**RE: Shipment Notification for: HG08-16MULTI(THIN_FLAT),ASAHI KASEI Job: 484214
(ID: 15036066 - 23)**

Product: **HG08-16MULTI(THIN_FLAT),ASAHI KASEI**

Partno: **PCR-032885-02**

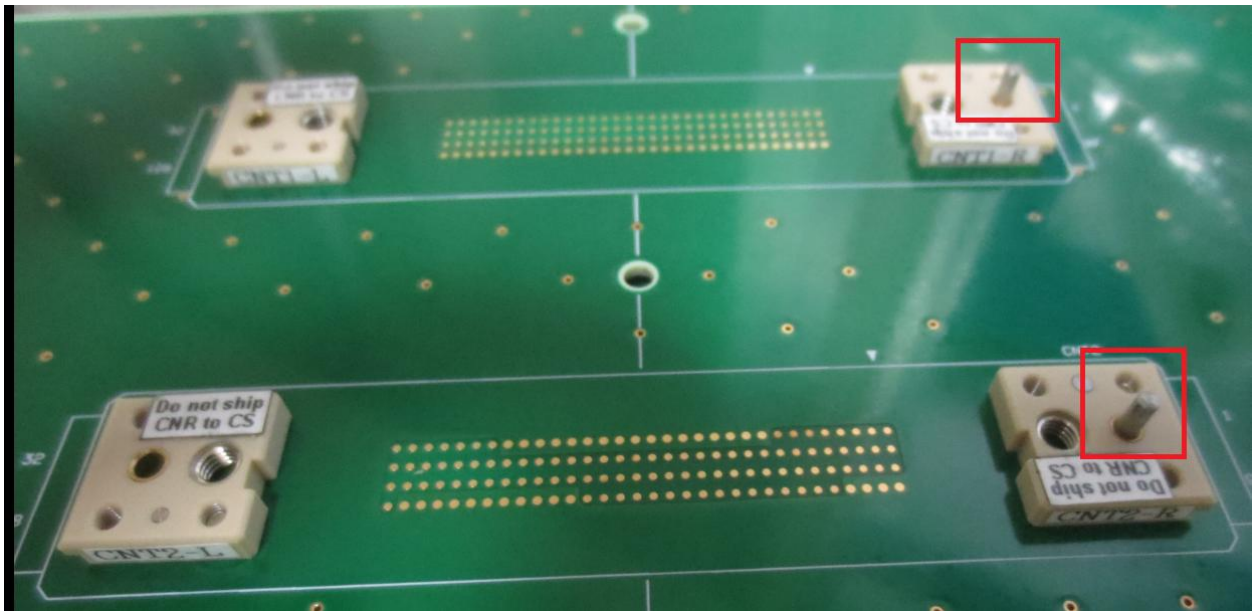
we cannot install full alignment pins for PCA CNR so holes of parts on PCB is round à it
have tolerance à this PCB can install but others cannot

Just thinking out solution: cut slot on PCA CNR and insert alignment pin on PCB to align

Pls follow as below for setup CNR for PCA test

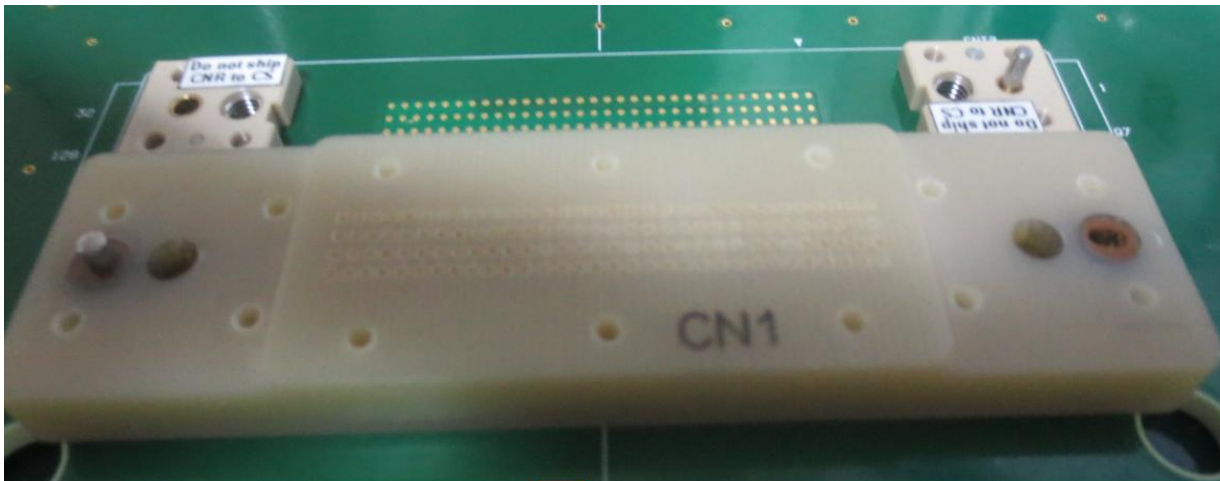
1. Insert pins to PCB first

2. Install connector as normal:

3. After finished card remove 2 align pins and store in box to use in next time

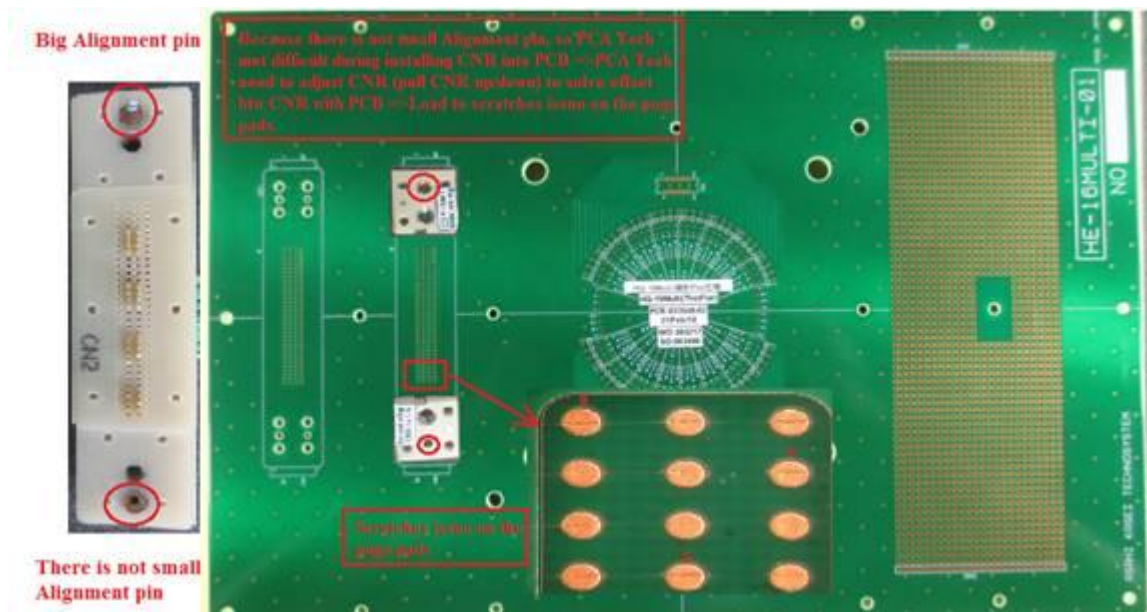
+ **Problem Description**: There are scratches on the pogo pads.

- This issue was happened during installing CNR for PCA testing. PCA Tech met difficult while install CNR into the PCB because VN CNR only has one big Alignment pin, there is not small Alignment pin so PCA Tech need to adjust CNR (pull CNR up/down) to solve offset between CNR with PCB à Lead to happen scratches issue on the pogo pads. Pls see below picture to refer.

+ **Root cause of problem** : CNR has not full Alignment pins.

+ **Preventive Action** :

- Show this issue to PCA team to take a note while install CNR into this PCB type.

- Don't allow to pull CNR up/down to solve offset between CNR with PCB à Must remove CNR and install again to solve offset.

- Study to build new CNR with full Alignment pins to solve offset issue between CNR with PCB.
